Technical Bulletin CS-3e RFI modification March 2010

**Subject: Microphone CS-3e    Serial Number Prior to #2792 \***

**Improve the physical ground connection and reduce exposure to Radio Frequency Interference**

**1. Connector contact**

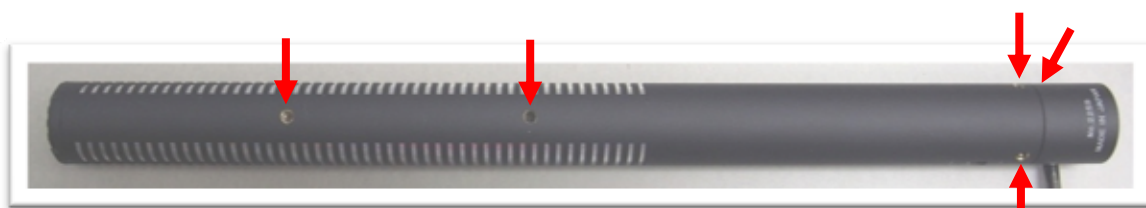
Remove the black paint on the inner part of the microphone connector shell as shown using sandpaper. This is to improve the electrical connection between the microphone and the cable plug connector shell.

Only remove the paint, not the black plating under the paint.

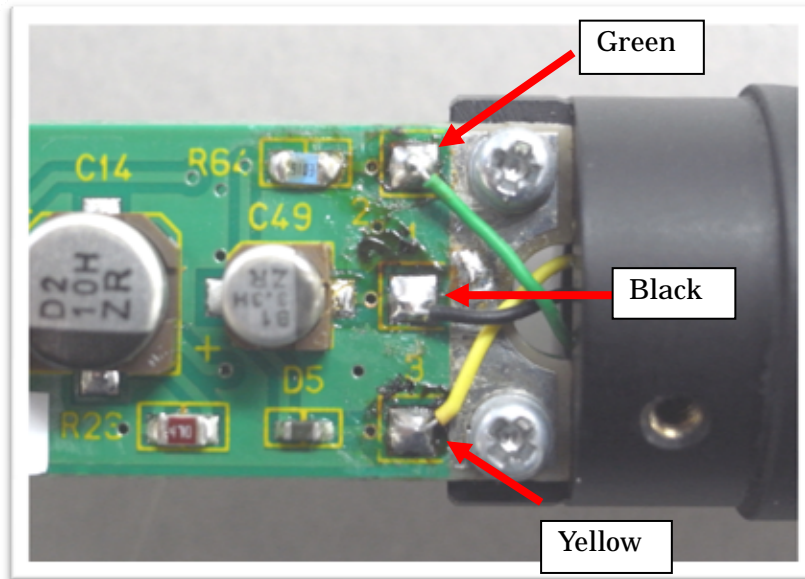
(a) Remove five screws

(b) Remove the outer tube

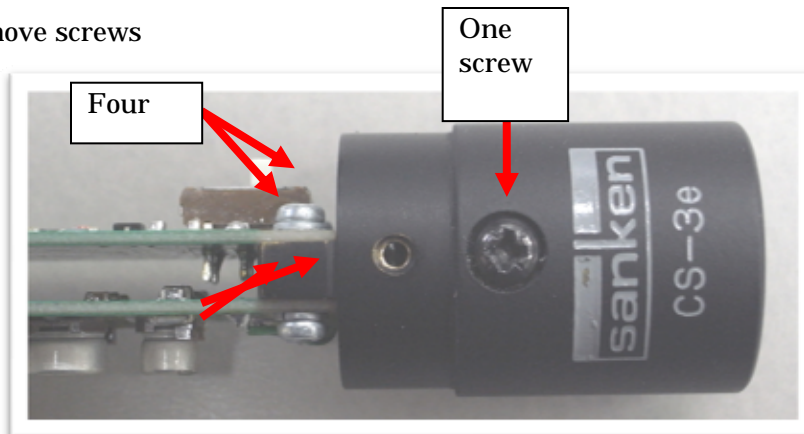
(c) Unsolder the three internal wires that come from the connector. \* Yellow/Green/Black

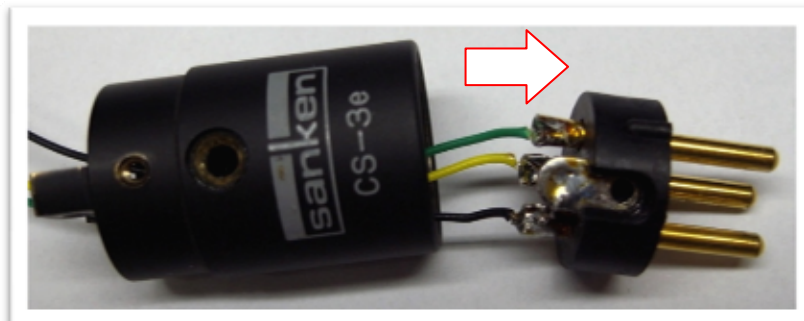
(d) Remove screws

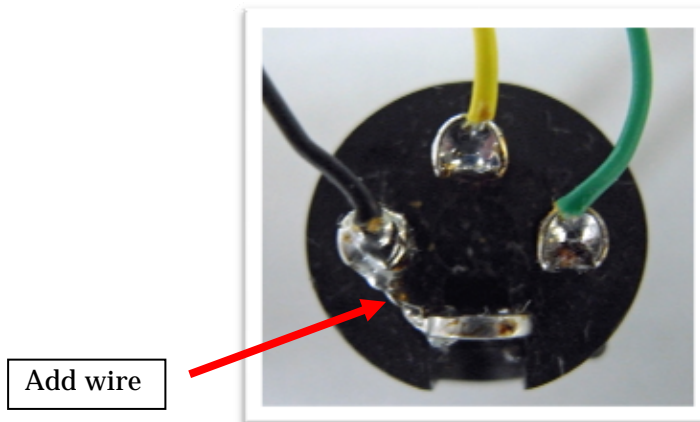
(e) Pull connector out of shell

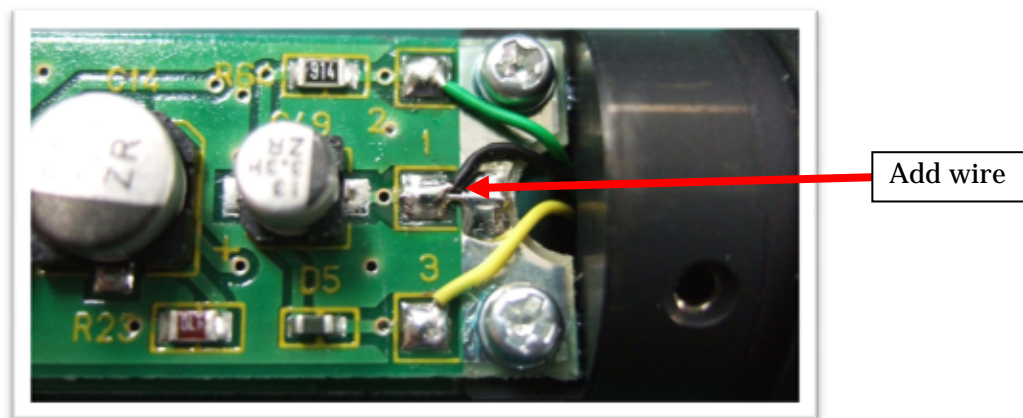
(f) Add wire from connector pin1 to shell terminal ground post.

Add a short wire between the solder pad labeled "1" and the backplane ground solder pad.
